NOTE: DRAWINGS SUBMITTED ARE AN ALTERNATE DESIGN REQUESTED BY W.R.KELSO CO. NOT AS DESIGNED BY FANNING & HOWIE. REF. QUOTE #970793 ALTERNATE DESIGN # 2 TAPER AND FILL ONLY.

Extruded Polystyrene Insulation
FOAMULAR[®]

Project: CHESTERTON H.S.
SWIMMING POOL
CHESTERTON, INDIANA

Drawing number: 4 of 6

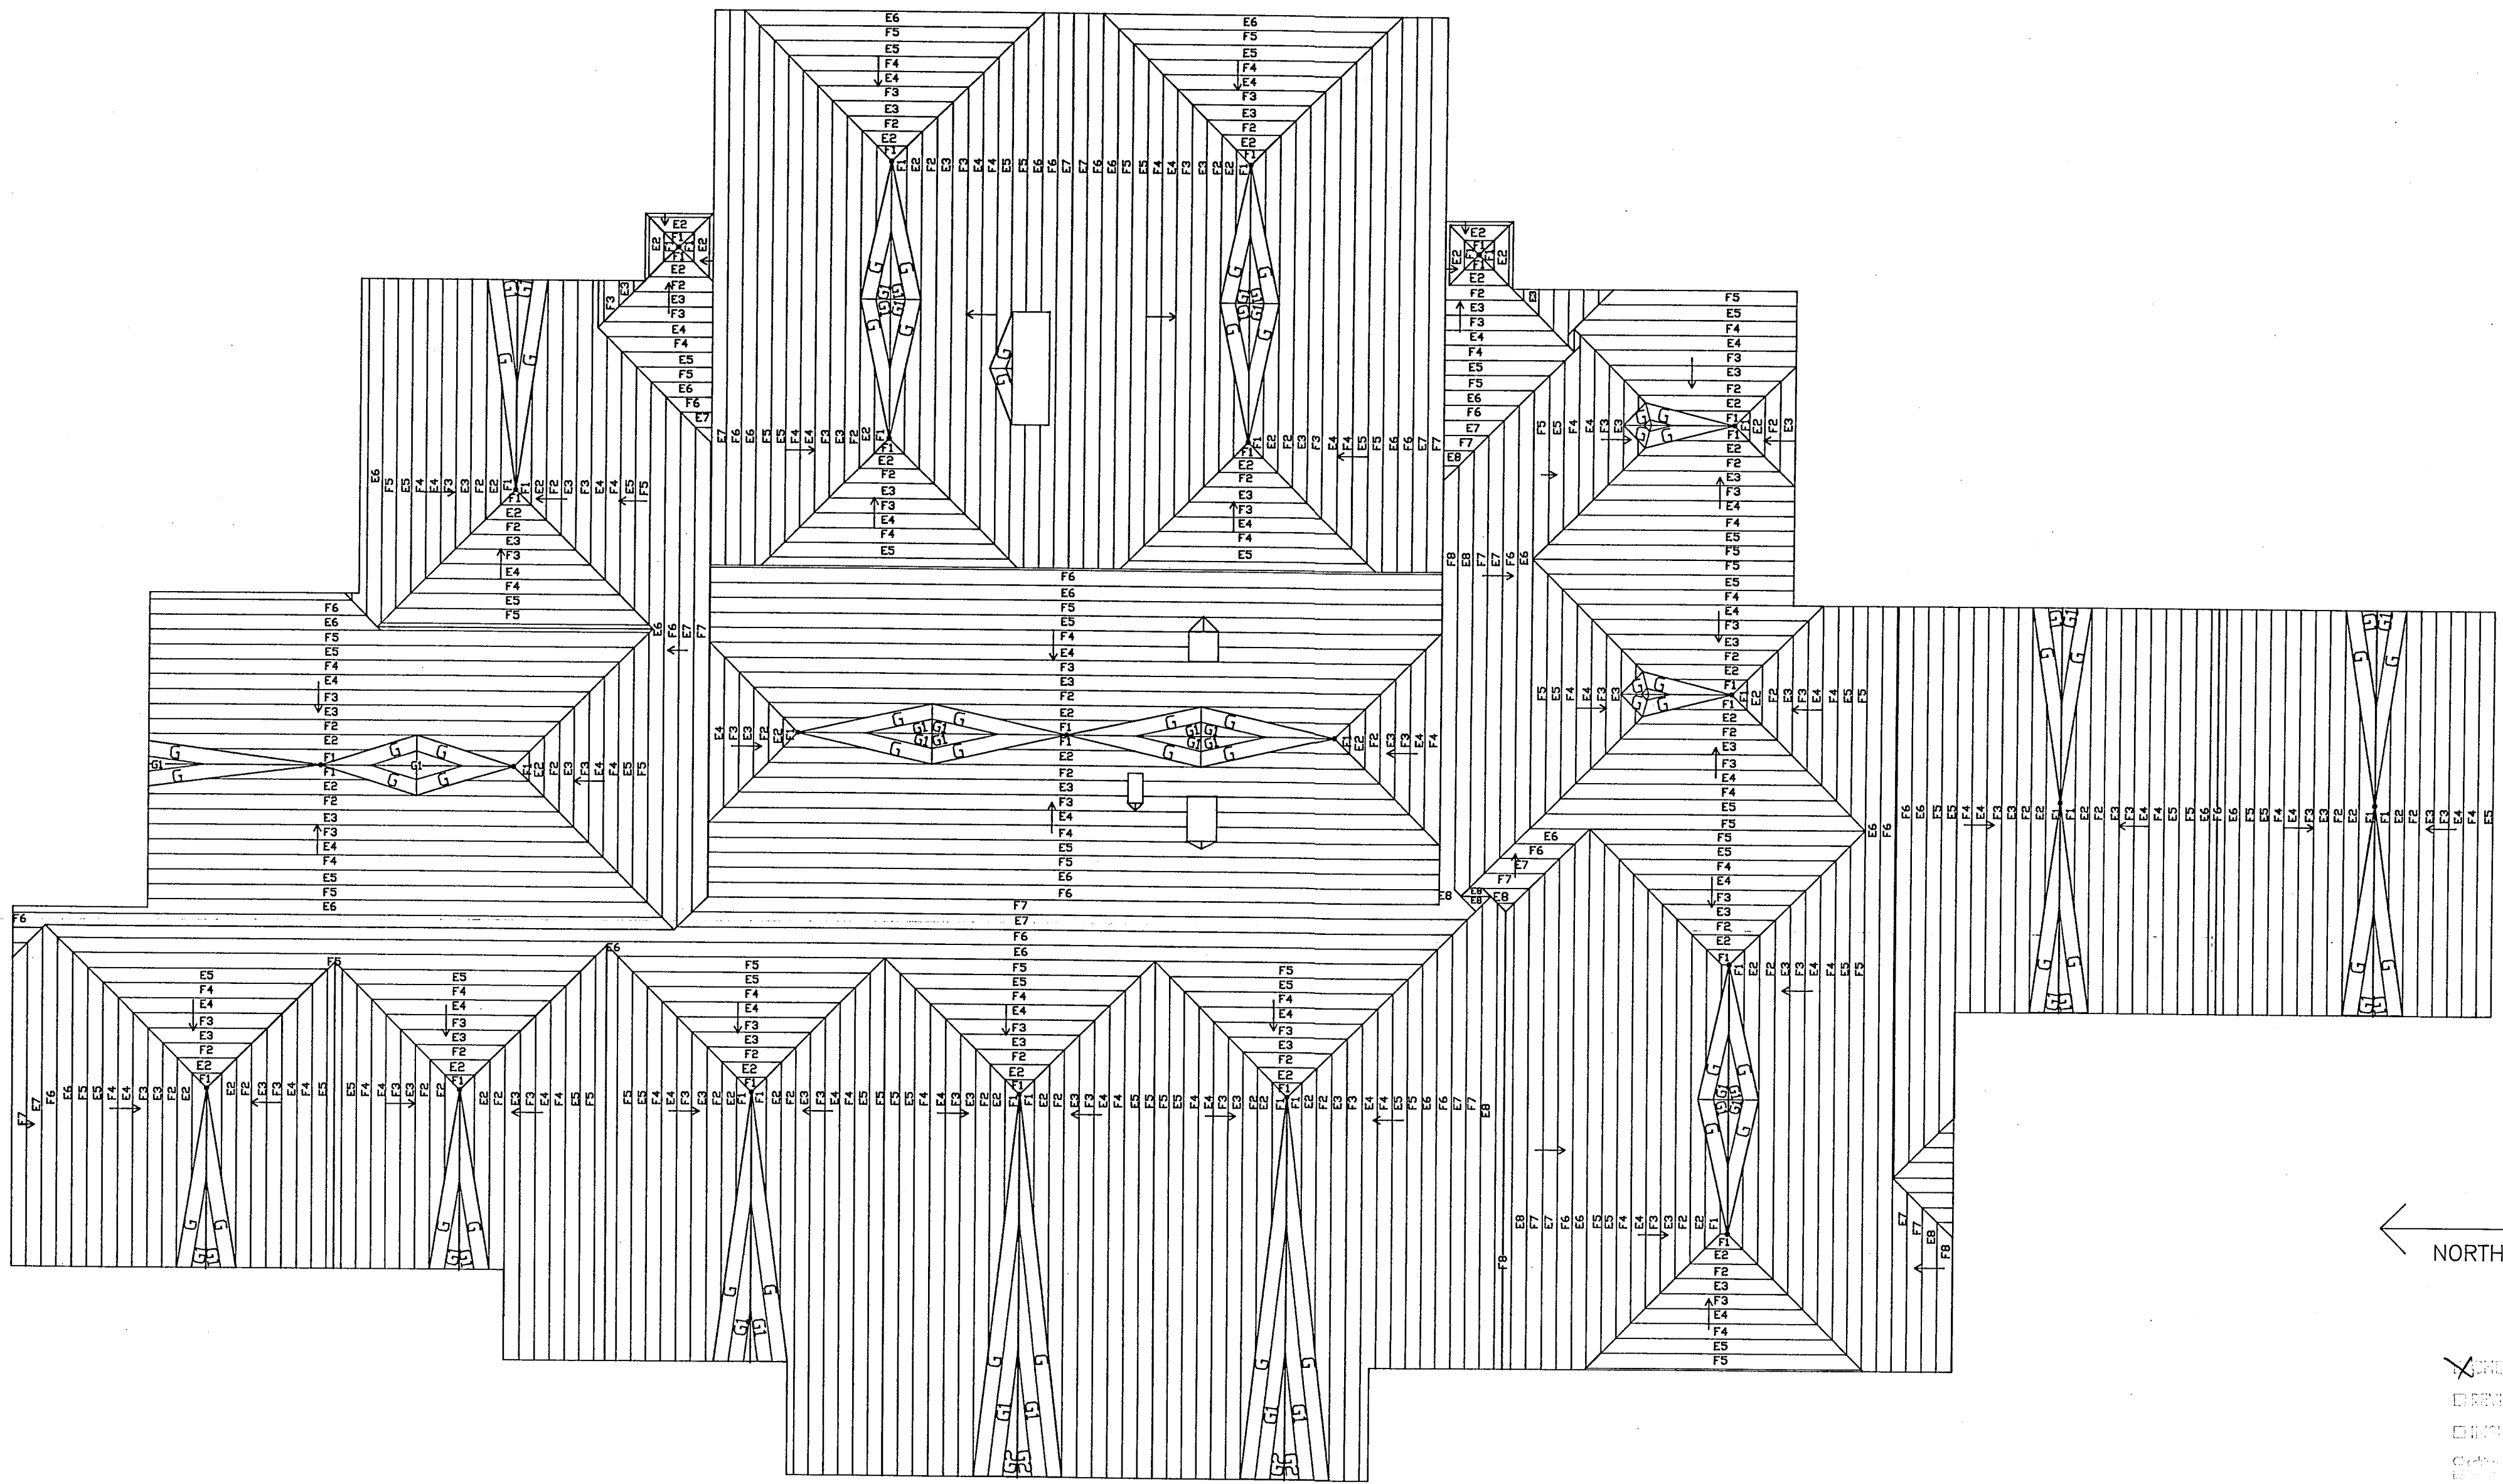
1. REVISED DRAWING FOR RELOCATION OF ROOF DRAINS PER W. R. KELSO.
